主旨: Re: Departmental Comments on A/NE-TKLN/100

PROPOSED TEMPORARY PUBLIC VEHICLE PARK (PRIVATE CAR ONLY) FOR A PERIOD OF 3 YEARS IN "RECREATION" ZONE

LOTS 67 S.B RP AND 70 S.B RP IN D.D. 80, LIN MA HANG ROAD, TA KWU LING NORTH, NEW TERRITORIES

# **Journey Time Delay Analysis**

Figure 1. Passing Bay Locations

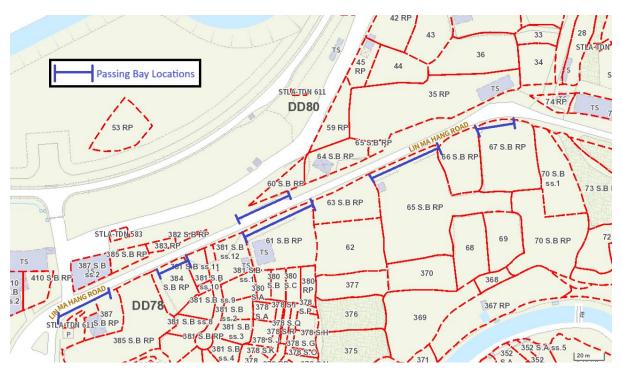
**Departmental Comments** Applicant's Response **Comments from the Transport Department** Attached, please find a journey time delay 1. Our previous comment "The applicant shall analysis study to justify and demonstrate the further justify and demonstrate the use of 300 use of 300veh/hr is adequate for the design veh/hr is adequate for the design flow capacity of flow capacity of Lin Ma Hang Road. Lin Ma Hang Road, including a journey time delay analysis study should be conducted to demonstrate the journey time in connection with different v/c ratios." has not been addressed. The passing bays of the section of Lin Ma Hang Road concerned cannot be considered as a single twolane local road. Also the length of passing bay claimed is inaccurate. The analysis submitted in the FI is considered inapplicable, owing to the fact that the capacity of this single track access road is significantly affected by the amount of kerb activities, pedestrian traffic, standing vehicles and development frontages etc. Our previous comment "The applicant shall When the proposed site is full, additional staff advise the management / control measures to be will be stationed near Ta Kwu Ling (Tsung Yuen implemented to ensure no queueing of vehicles Ha) Bus Station to alert drivers that the outside the subject site" has not been addressed. subject site is full. And additional staff will be There is no available space for queueing of stationed near the entrance of the proposed vehicles outside the subject site. The applicant site to help direct traffic away from the shall further supplement and propose additional subject site and towards the nearest available measures to prevent queueing of traffic e.g. parking lot. provision of parking information." has not been addressed. It would be considered too late to inform the public that the carpark is full outside the subject site. The applicant should provide the parking information well in advance and make the public aware the real time information of the parking vacancy.has not been addressed. There is no available space for queueing of vehicles outside the subject site. The applicant shall further supplement and propose additional measures to prevent queuing of traffic e.g. provision of parking information to the public.

- Treating the road as single-track with intermittent passing bays (not two-lane)
- Using verified site geometry (130 m bays, revised, see Figure 1)
- Incorporating kerbside activities, pedestrians, standing vehicles, and frontages
- Presenting v/c-based journey time analysis
